# Access Compliance Report

## Public Rights-of-Way

### (Curb Ramps)

Intersection ID: 15162	Main Street: EWING_AV	Cross Street: IDEAL_WY	Location: NE
ADA ID: 70C70B645A6B	Ramp Type: Perp	Initial Pass/Fail: Fail	Overall Compliance: No
		Severity Score: 12.5

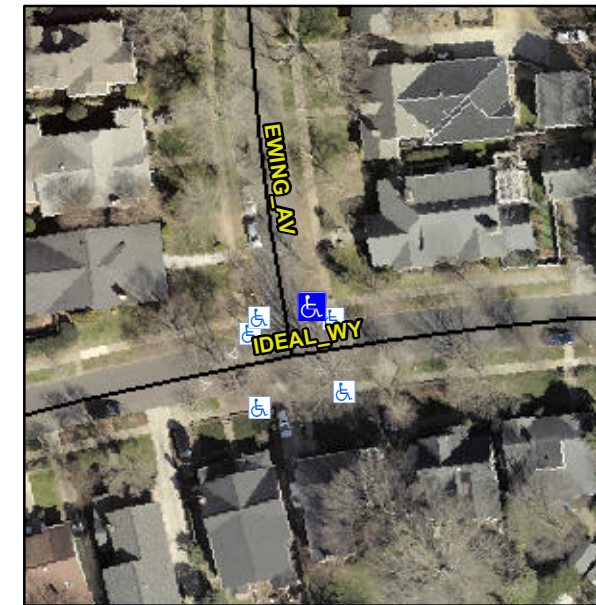
**Not Found, R304.2.2**

Compliance	Description	Data	Compliance	Description	Data
N/A	Ramp Length (in)	76.0	No	Ramp Slope (%)	9.0
Yes	Ramp Width (in)	62.0	Yes	Ramp XSlope (%)	1.8
N/A	Flare Type LT	N/A	N/A	Flare Type RT	N/A
N/A	Flare Slope LT (%)	N/A	N/A	Flare Slope RT (%)	N/A
N/A	Flare Traversable LT?	N/A	N/A	Flare Traversable RT?	N/A
N/A	Landing Length (in)	N/A	N/A	DWS Provided?	N/A
N/A	Landing Width (in)	N/A	N/A	DWS Contrast?	N/A
N/A	Landing Slope (%)	N/A	N/A	DWS Length (in)	N/A
N/A	Landing X Slope (%)	N/A	N/A	DWS Full Width?	N/A
N/A	Landing Curb? (Y/N)	N/A	N/A	DWS Offset (in)	N/A
N/A	Shared Landing?	N/A			
N/A	Gutter Ponding?	N/A	N/A	Gutter Slope (%)	N/A
N/A	Gutter Lip Ht (in)	N/A	N/A	Gutter X Slope (%)	N/A
N/A	Painted X Walk1?	No	N/A	Painted X Walk2?	N/A
	X Walk 1 Direction	To W		X Walk 2 Direction	N/A
N/A	X Walk 1 Width (in)	N/A	N/A	X Walk 2 Width (in)	N/A
	X Walk 1 Slope (%)	1.3		X Walk 2 Slope (%)	N/A
	X Walk 1 X Slope (%)	1.9		X Walk 2 X Slope (%)	N/A

**Remove & Replace Entire Ramp.**
